4352B-11

S E R V I C E N O T E

Agilent 4352B VCO/PLL Signal Analyzer

Part Number Changes for Power Supply Switch Parts

Figure 1 Replaceable Parts from Bottom View

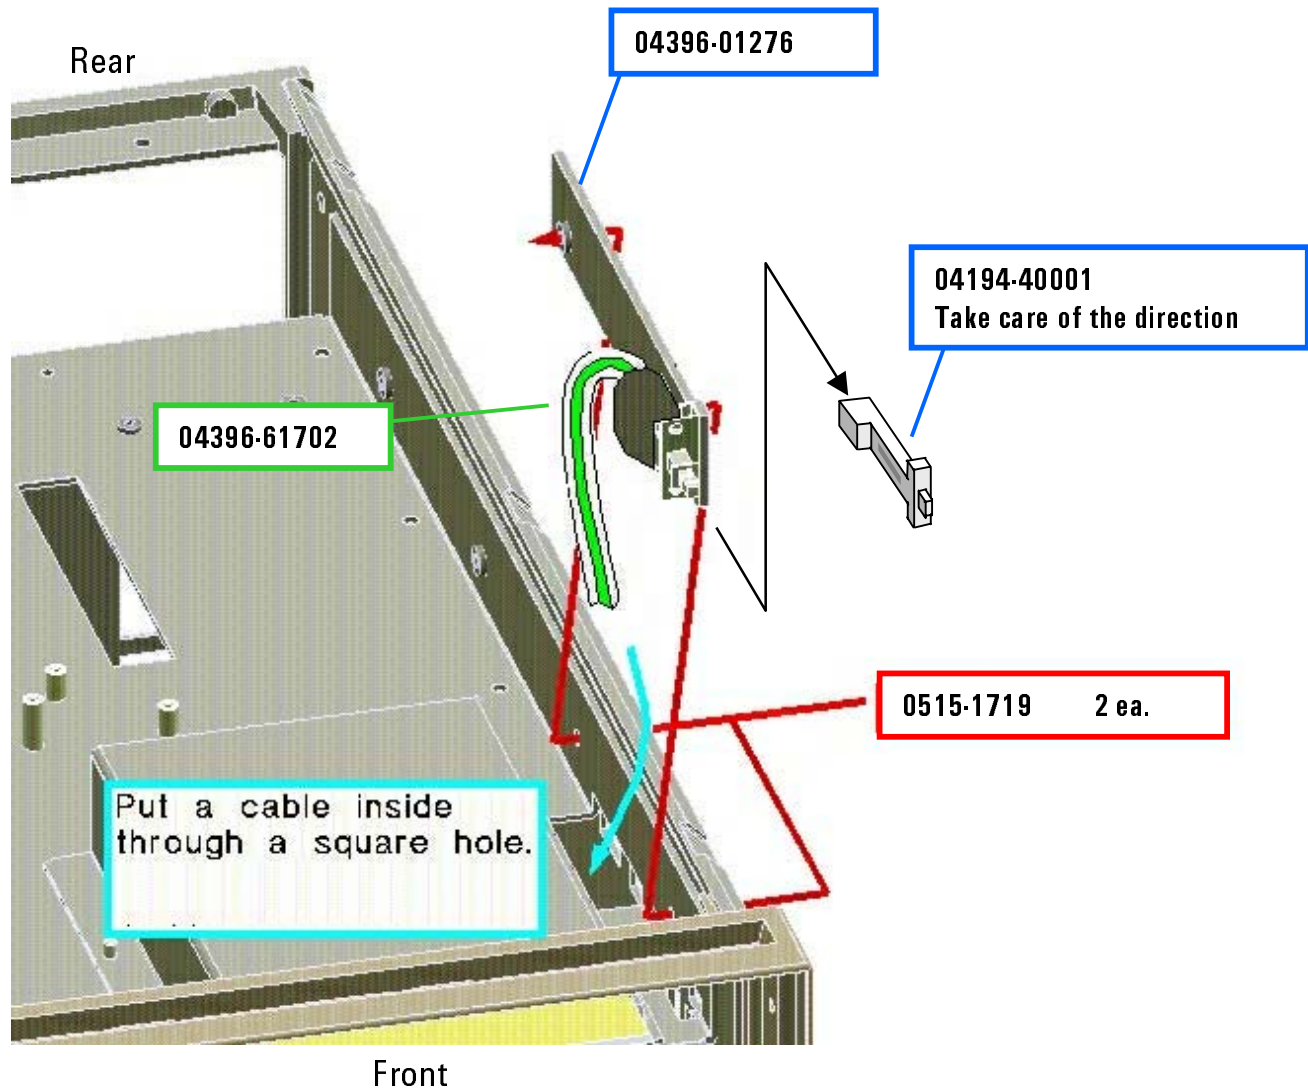
The power switch holder (P/N 04396-01274) and the power switch assembly (P/N 04396-61701) for the 4352B were obsoleted and replaced with new parts. Additionally, a new rod (P/N 04194-40001), which is inserted between the switch and LINE push-button, is set up.

When either the switch holder (P/N 04396-01274) or the switch assembly (P/N 04396-61701) is faulty, replace all the parts listed in Table 1 with the new parts shown in Table 2. Insert the rod (P/N 04194-40001) between the power switch and LINE push-button as shown in Figure 1.
